D	20.02.20	LH	WB	SECTION 4.55 MODIFICATION ISSUE
C	14.02.20	LH	WB	ISSUED FOR CC4A
B	25.11.19	MW	WB	BIKE PARKING UPDATE
A	25.01.19	MT	SF	PC
30	15.09.19	BA	WB	ISSUE FOR INFORMATION
29	03.07.19	LH	WB	ISSUE FOR CROWN CERTIFICATE 2
28	26.06.19	LH	WB	ISSUE FOR CROWN CERTIFICATE 3
27	17.06.19	YL	WB	GENERAL UPDATE
26	05.12.18	BY	WB	UPDATED CAVEAT TENDER ADDENDUM
25	28.11.18	BY	WB	CAVEAT TENDER ADDENDUMS
24	22.11.18	MW	WB	BIKE CAGE ADDED
23	13.09.18	JACOBS	WB	TENDER ISSUE
22	31.08.18	MW	WB	DESIGN DEVELOPMENT
21	01.08.18	MW	WB	ISSUED FOR COORDINATION
REV	DATE	DRAWN	REV'D	APPROV

CONCORD HOSPITAL
REDEVELOPMENT STAGE 1

GA- BASEMENT LEVEL ZONE 2

TITLE
GA - LOWER GROUND LEVEL ZONE
2

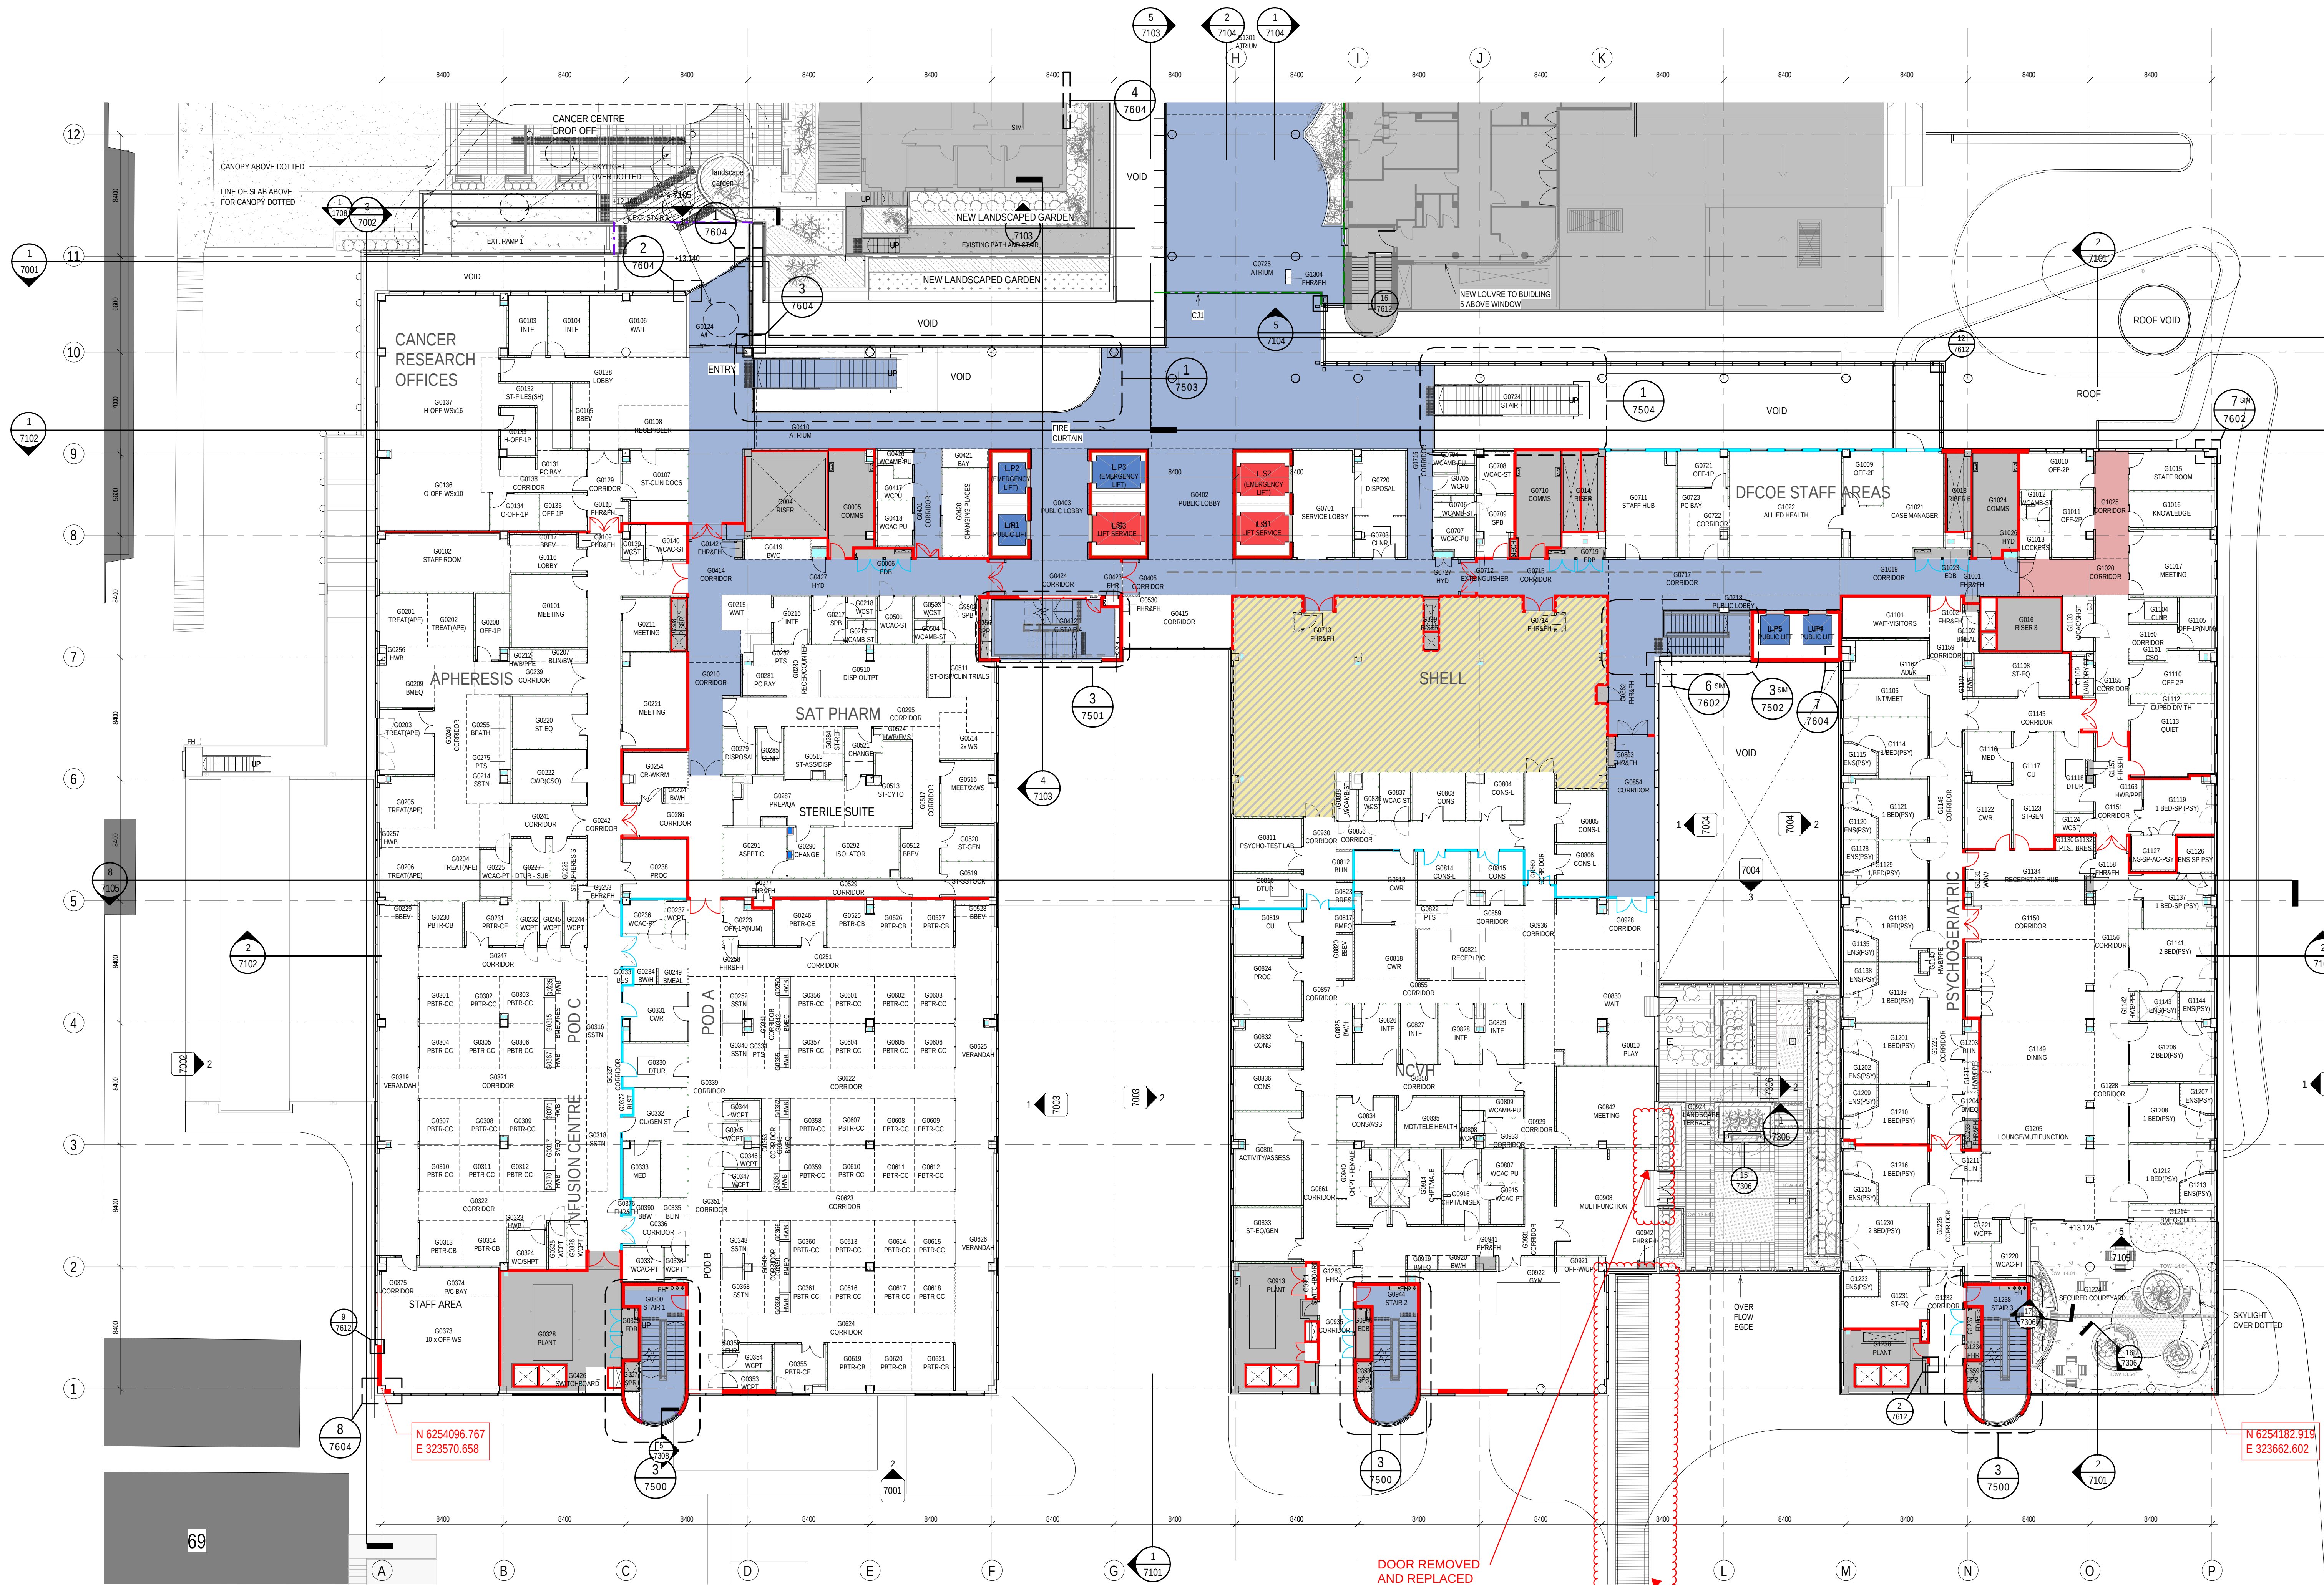
CHANGE FROM
BRIDGE LINK TO BED
REPAIR WORKSHOP

CHANGE FROM 4
MEETING ROOM INTO
1 MEETING ROOM

DOOR WAS ALWAYS
PART OF ORIGINAL DA

DOOR REMOVED AND
REPLACED WITH WINDOW

PROPOSED NEW COVER
WALKWAY TO EXISTING
HELIPAD
